# PD Modification Application: PRS 24-0536

BOCC Land Use Meeting Date: August 13, 2024

Request: Minor Modification to PD 22-0083

The applicant is seeking a Minor Modification to remove one of the three access points to allow an existing building to remain, to provide additional stormwater retention ponds, and other internal site plan revisions including shifting building and parking areas to accommodate the additional retention ponds. The applicant proposes to maintain the approved square feet of the structures and the new buildings will be slightly smaller due to the proposal to renovate and keep the existing structure equating in a net zero increase in overall non-residential structures. Nor is the applicant proposing any revisions to the approved uses, density or intensity of the project.

### 2.4 Proposed Site Plan

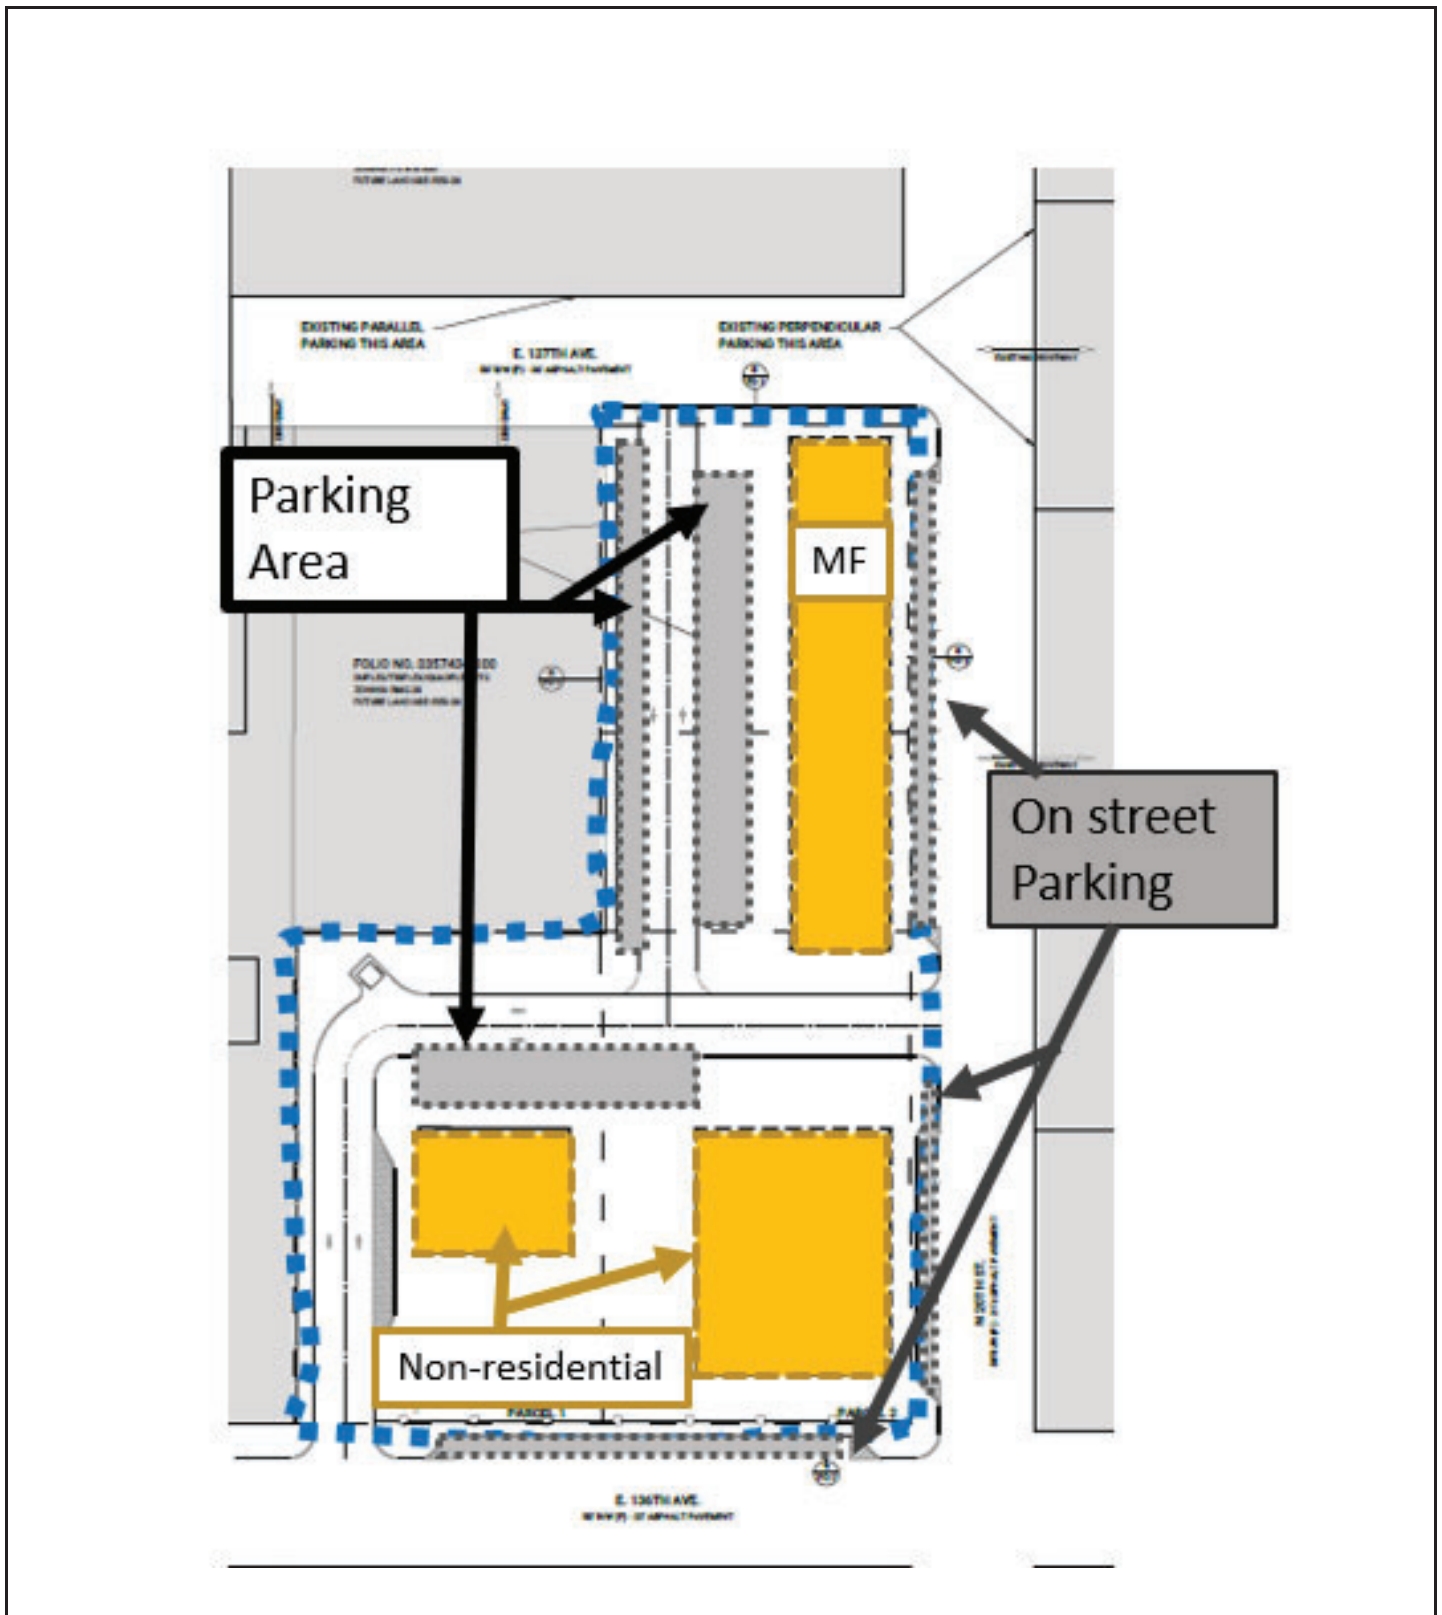
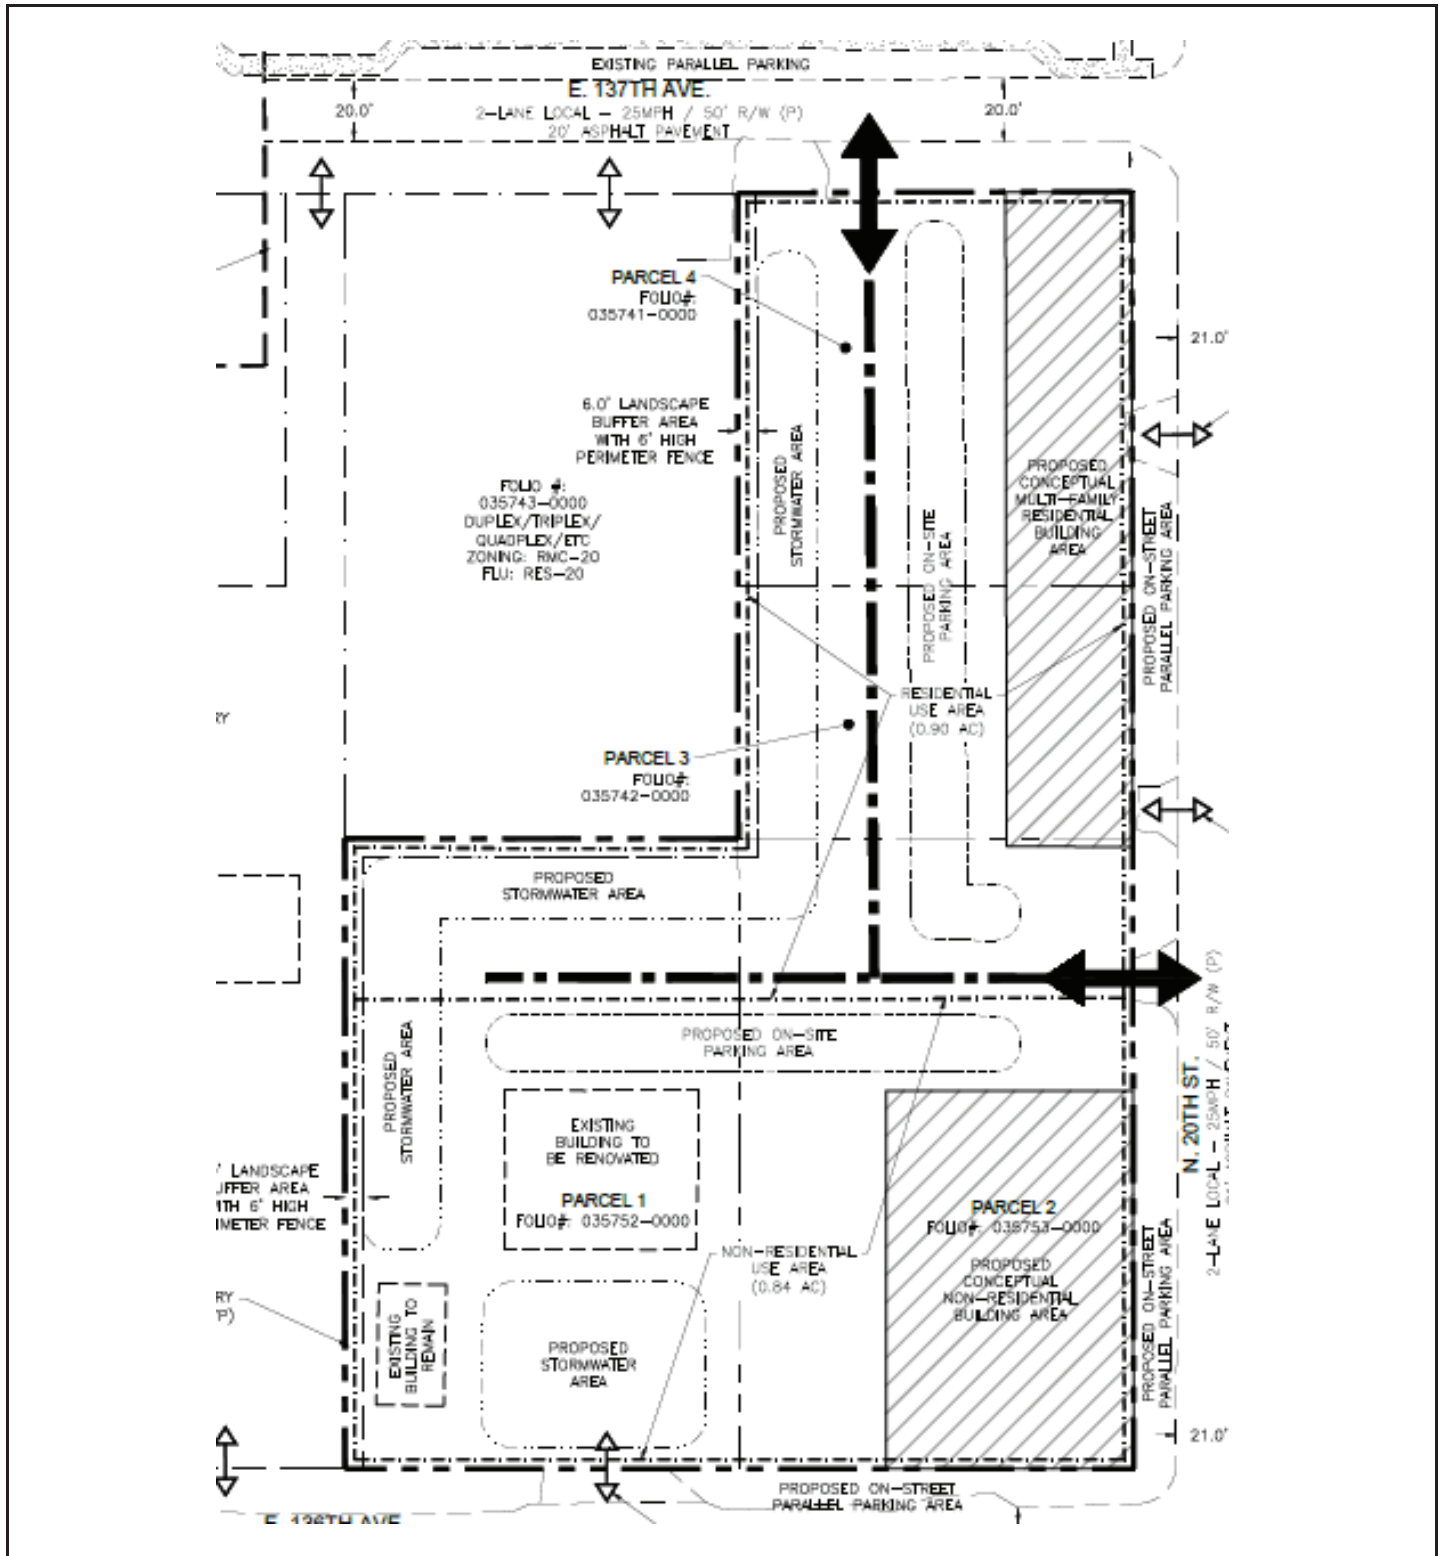
Existing Approval(s):	Proposed Modification(s):
1. Three access points located on the north, east and south.	1. Remove southern access point connecting to 136 <sup>th</sup> Avenue. Other two access points to remain.
2. Existing structure/building proposed to be demolished.	2. Existing structure/building to be maintained and renovated.
3. Existing stormwater pond located in the NW center area of the subject site.	3. Increase the stormwater pond to include the predominance of the western boundary of the subject site.

The applicant proposes to maintain the approved square feet of the structures and the new buildings will be slightly smaller due to the proposal to renovate and keep the existing structure equating in a net zero increase in overall non-residential structures. Nor is the applicant proposing any revisions to the approved uses, density, or intensity of the project. The increased stormwater retention areas along the western perimeter of the property requires the parking being shifted further east to accommodate the stormwater areas resulting in an increased separation from the adjacent property.

- Revise “Proposed Conceptual Multi-Family Residential Building Area” to “Proposed Conceptual Multi-Family Residential Building & Parking Area”.

## 8.2 Proposed Site Plan (Full):

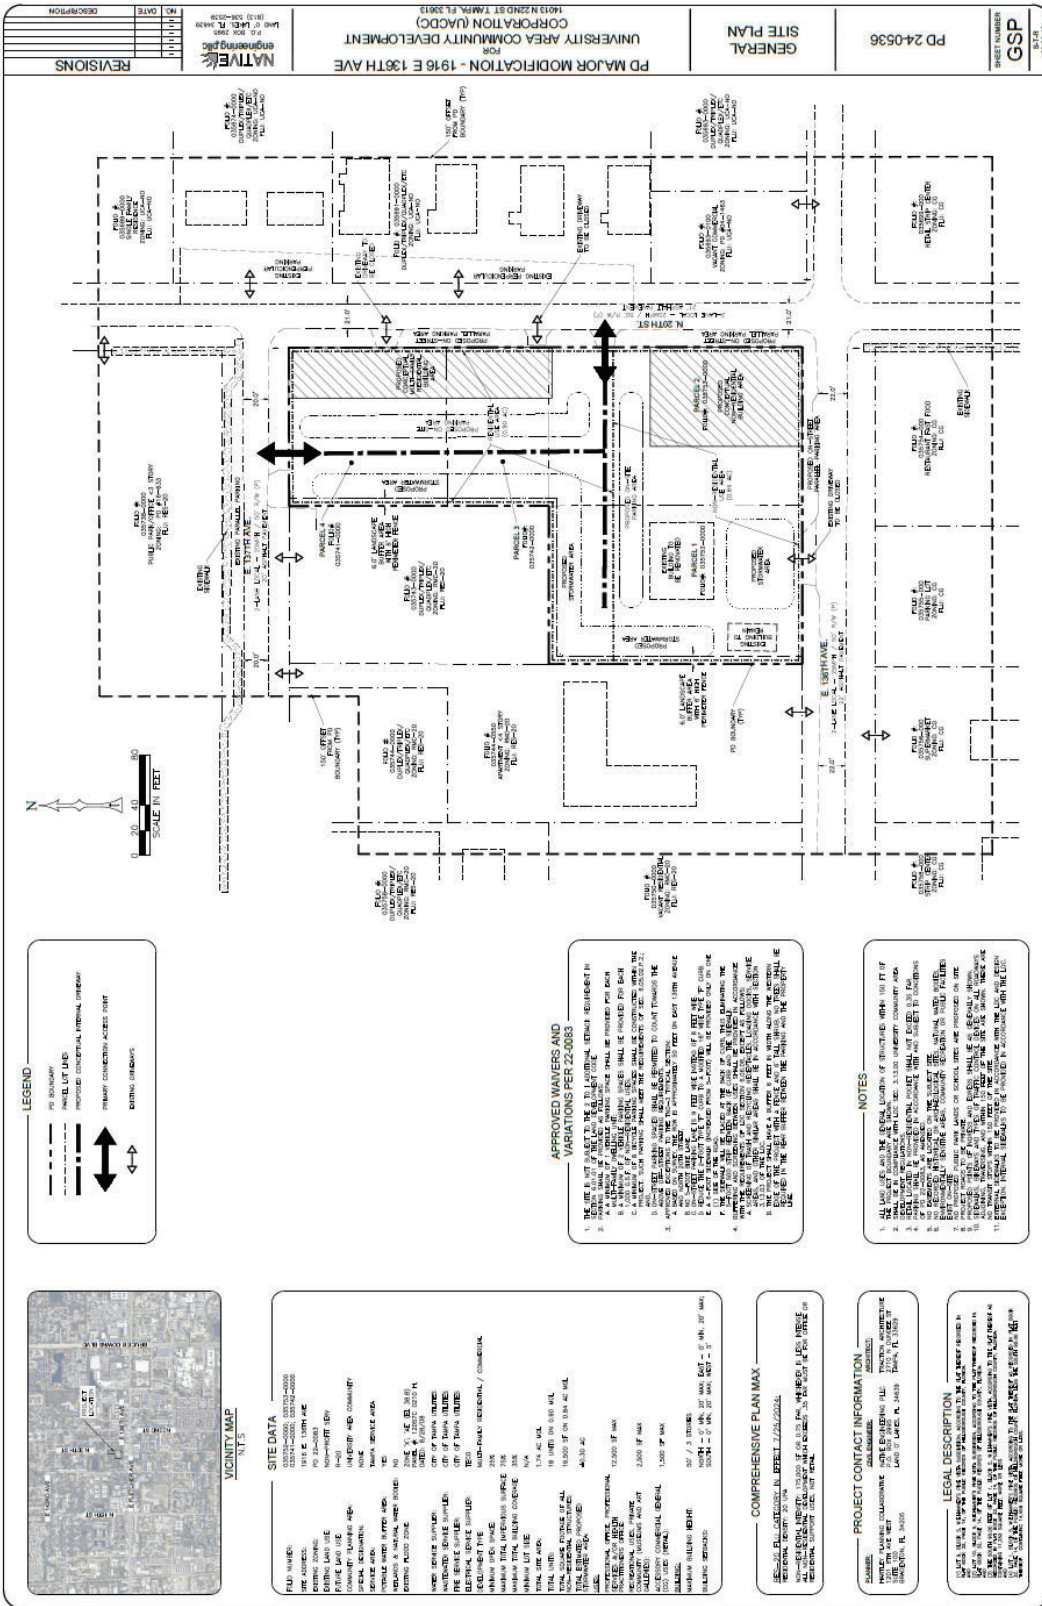
1. The project shall be permitted the following vehicular access:

- ~~a. One (1) access driveway on E. 136<sup>th</sup> Ave.;~~
- b. One (1) access driveway on E. 137<sup>th</sup> Ave.; and,
- c. One (1) access driveway on N. 20<sup>th</sup> St.

[Staff recommends revision to this condition in order to reflect the proposed minor modification and submitted site plan.]
